Draft Campsie Master Plan Site Specific Review

Joint Panel Report

Site C1: 124–142 Beamish Street and 16–18 Ninth Avenue

Figure 39: Recommended setbacks

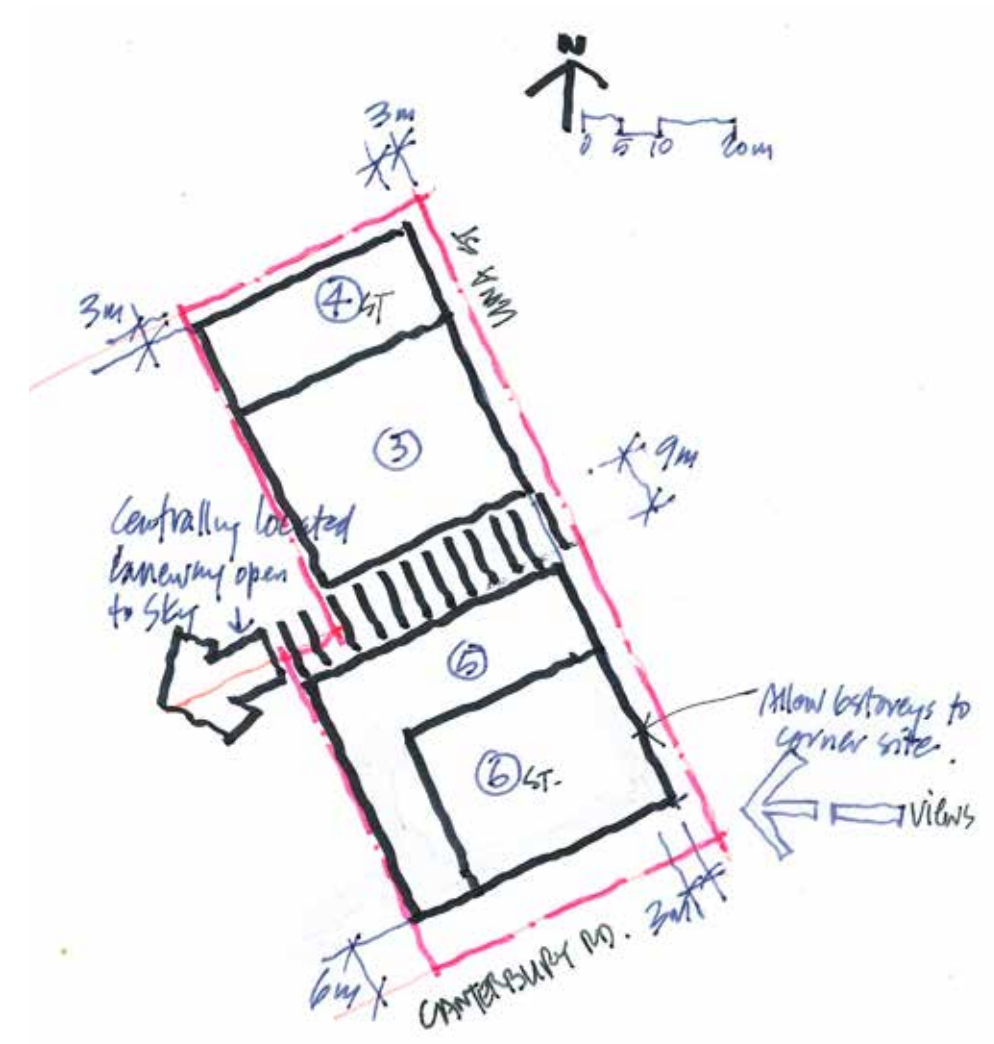
Residential uses are prohibited in the B6 zone which encourages a range of commercial and employment generating uses, particularly those with a medical focus. The Panel agrees with this direction of the Master Plan and does not support the proposed introduction of residential uses on this site.

A continuous centrally located laneway open to the sky is considered essential to service commercial uses fronting both street and to break up the scale and built form of development within the block.

In terms of built form the Panel considers that this corner site can support 6 storeys to Canterbury Road and 4 Storeys to Perry Street. This will strengthen and 'bookend' the large corner site, without disrupting a step up in height through to Beamish Street. It also provides some variety and massing modulation of the form of buildings addressing the streets. The Panel's recommendation for a minor increase to the FSR responds to this modified built form.

- Retain existing B6 Enterprise Corridor zoning
- Allow FSR of 2.0:1 (south of laneway) and 1.5:1 (north of laneway).
- Maintain 6m setback to Canterbury Road, consistent with approach along this length of the corridor.
- Retain street setbacks as per draft Master Plan
- Allow heights of:
 - 6 storeys on the corner of Canterbury Road and Una Street, stepping down to 5 storeys to address the site's western boundary and central laneway; and
 - a majority of 3 storeys for the part of the site north of the central laneway, stepping up to 4 storeys on the Perry Street frontage.

Refer to Figure 39.
